HISTORIC AND DESIGN REVIEW COMMISSION

HDRC CASE NO: 2020-154 ADDRESS: 126 WICKES

OWNER: Roof replacement TYPE OF WORK: March 18, 2020

The applicant is requesting a Certificate of Appropriateness for approval to reroof the structure including:

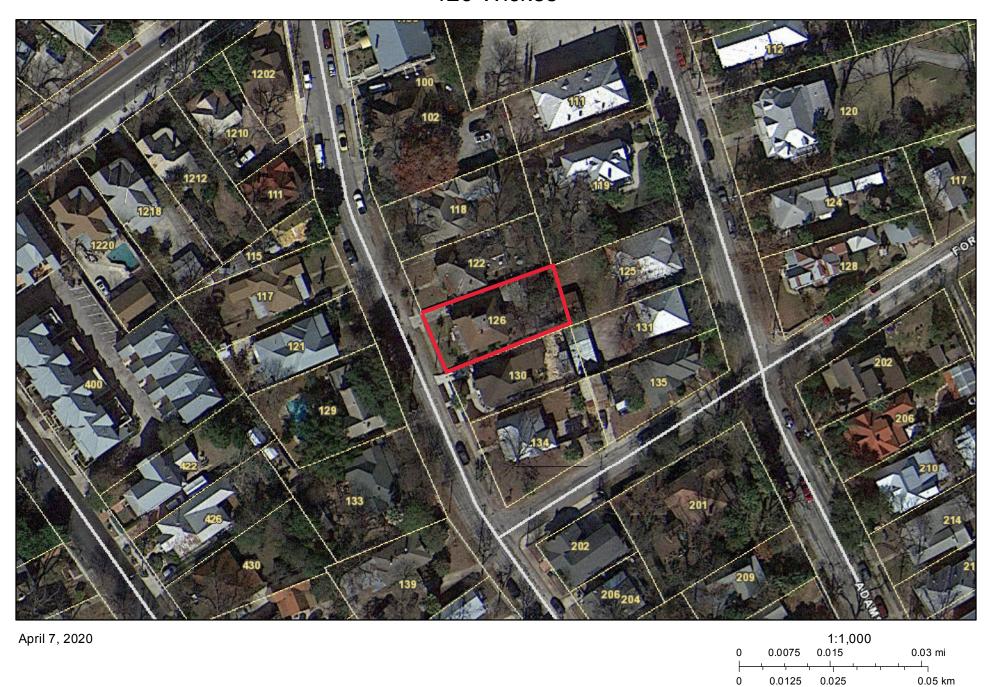
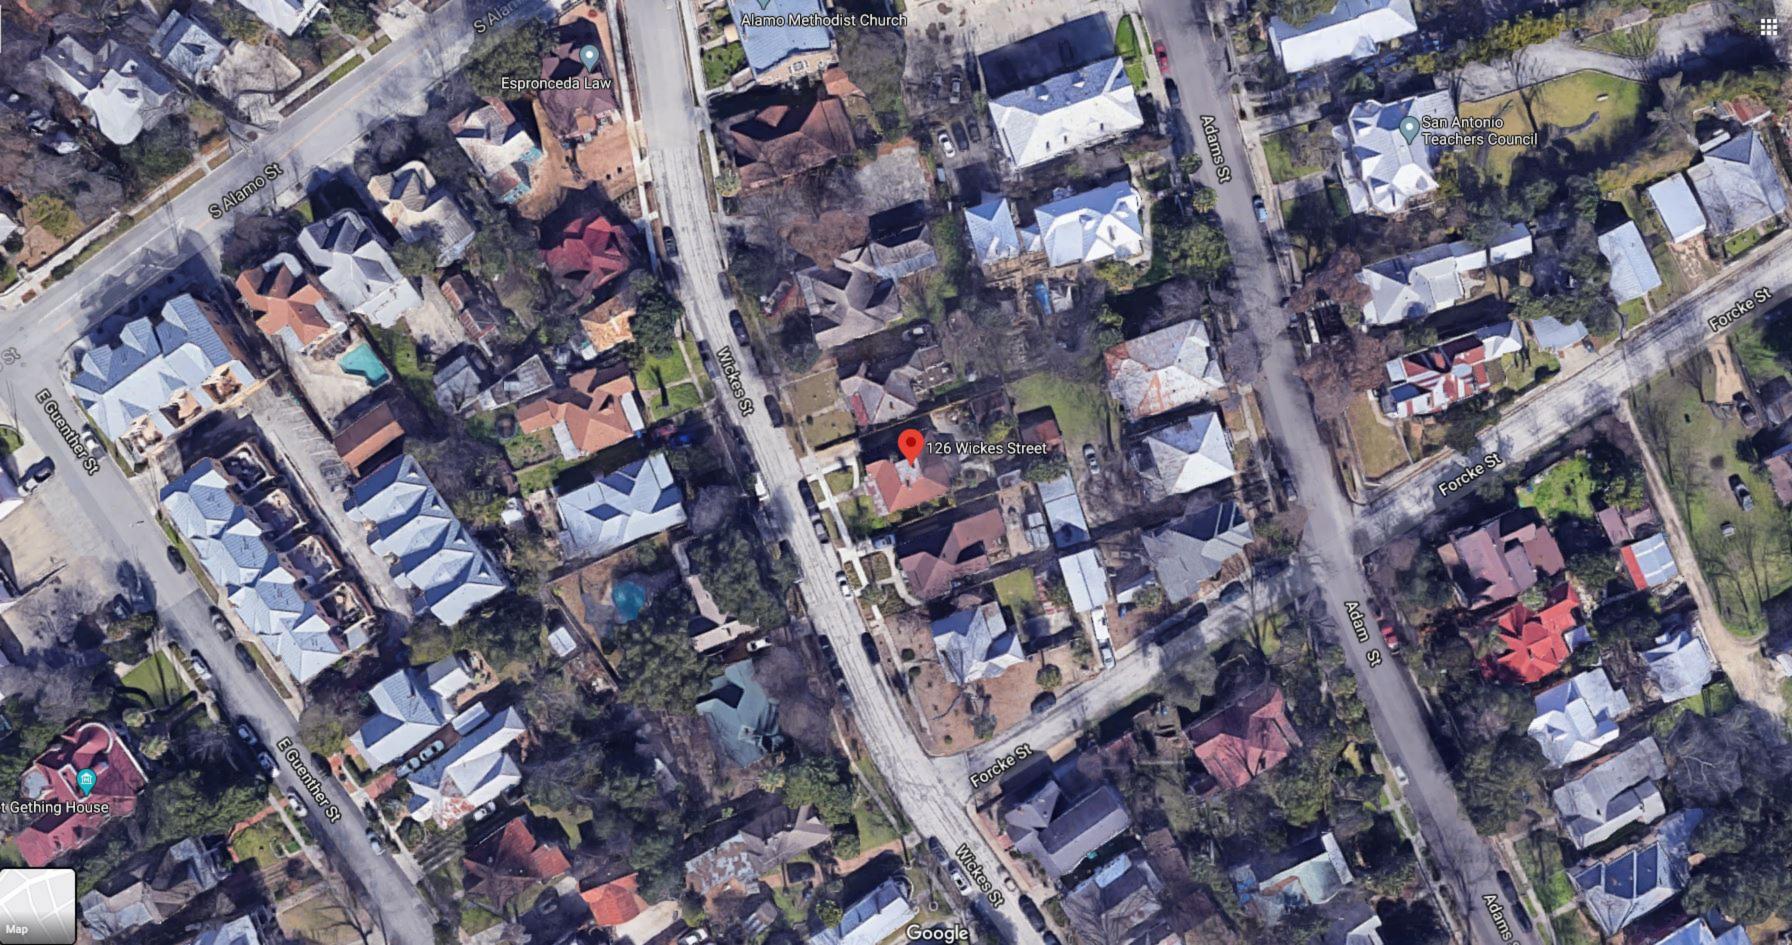
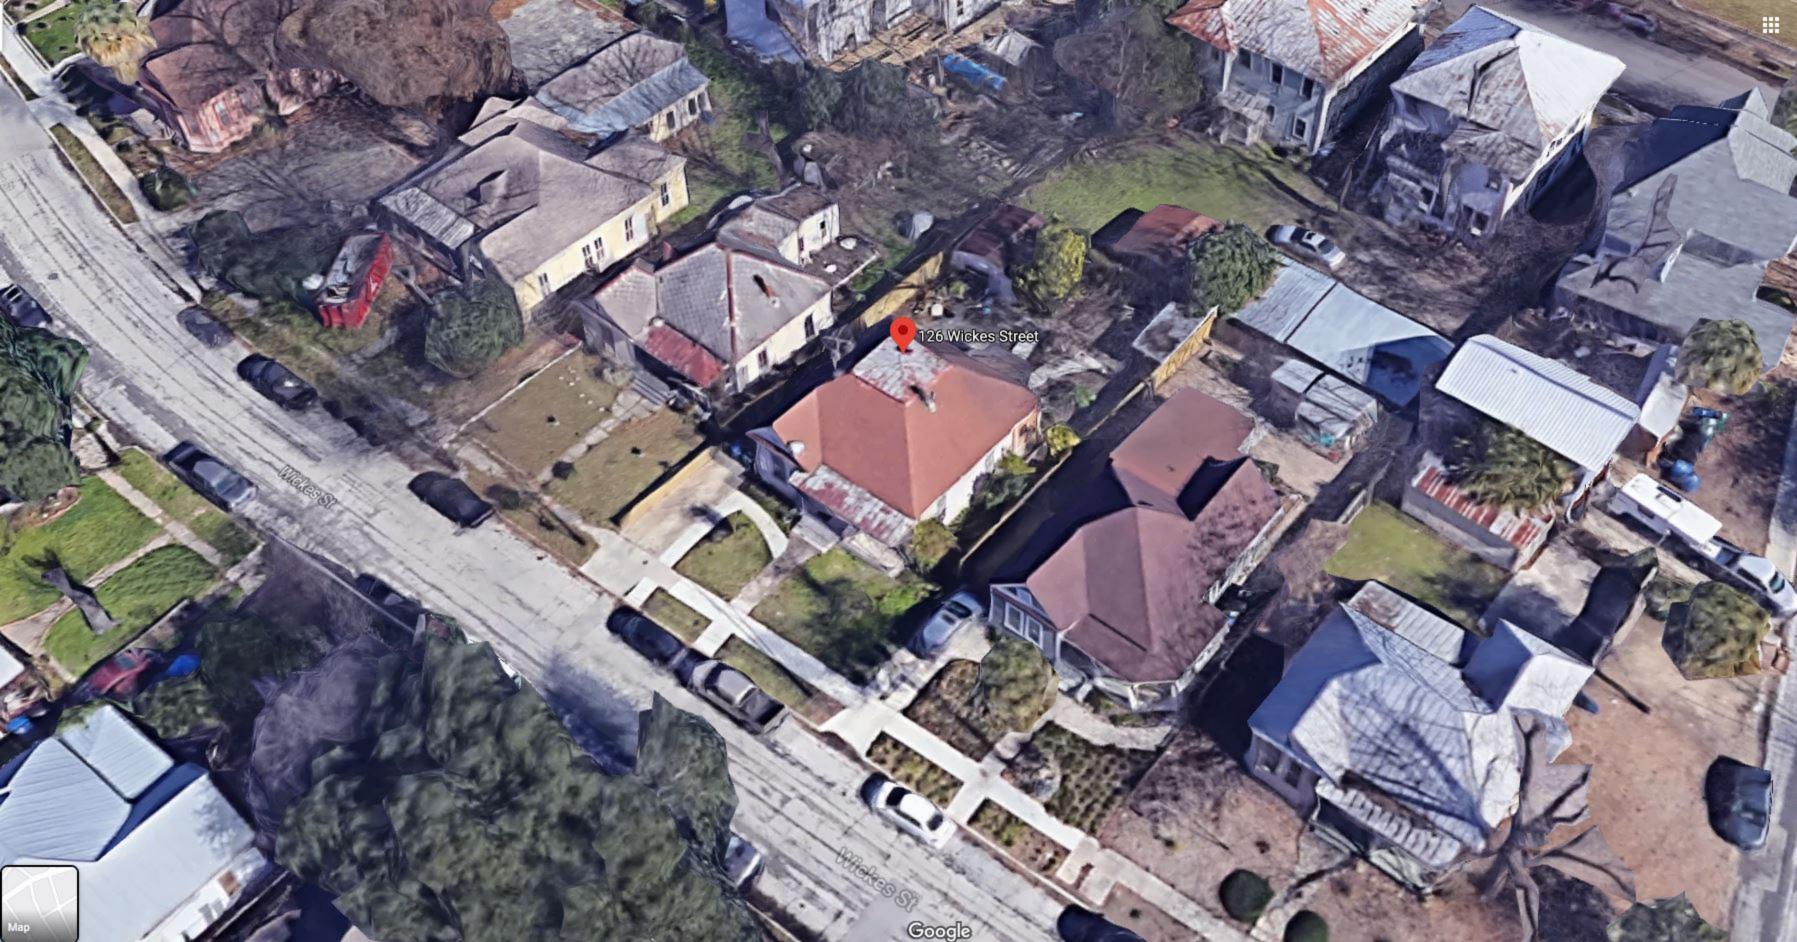
- d. ROOF FORM The applicant has proposed to eliminate the flat roof portion of the hipped roof to instead feature a pyramidal roof with a single point. Per the Guidelines for Exterior Maintenance and Alterations 3.B.ii., applicants should preserve the original shape, line, pitch, and overhang of historic roofs when replacement is necessary. Staff finds that the original roof form should be restored including the flat roof portion, standing seam metal material, and metal cresting.

- e. CHIMNEY The applicant has proposed to remove the two chimneys. Per the Guidelines for Exterior Maintenance and Alterations 3.B.iii., applicants p reserve and repair distinctive roof features such as cornices, parapets, dormers, open eaves with exposed rafters and decorative or plain rafter tails, flared eaves or decorative purlins, and brackets with shaped ends. While the applicant has verbally agreed to restore the chimneys, no measured drawings or photo documentation that supports a good faith effort towards compliance has been submitted. Staff finds that the chimneys should be restored to their original location and design, features as much original brick material as possible, and that a measured drawing is submitted to staff prior to any further work.

Staff does not recommend approval of item 1 and 2 based on finding b through e. Staff finds that the original roof form should be restored including the flat roof portion, standing seam metal material, and metal cresting. The chimneys should be restored to their original location and design, feature as much original brick material as possible, and that a measured drawing is submitted to staff prior to any further work.

Photographs

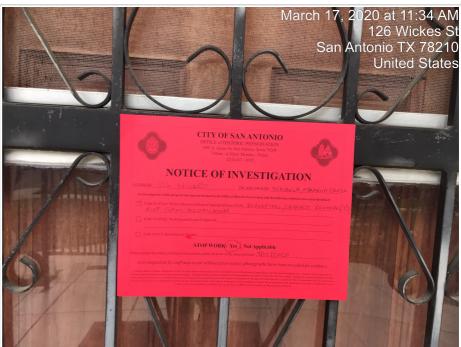
OILO VIOIL	
Date	03/17/2020
Time	11:35 AM (-5 GMT)
Context	citizen report
Present Staff	Huy Pham, Edward Hall
Present Individuals	Contractor(s)
Types of Work Observed	Exterior Maintenance and Alterations
Amount of Work Completed	75%
Description of work	Reroofing, removal of 2 brick chimneys, roof form modification
Description of interaction	Staff spoke with two subcontractors who said their project manager obtain approvals. Staff advised that a COA or permit had not been issued and all work should stop.
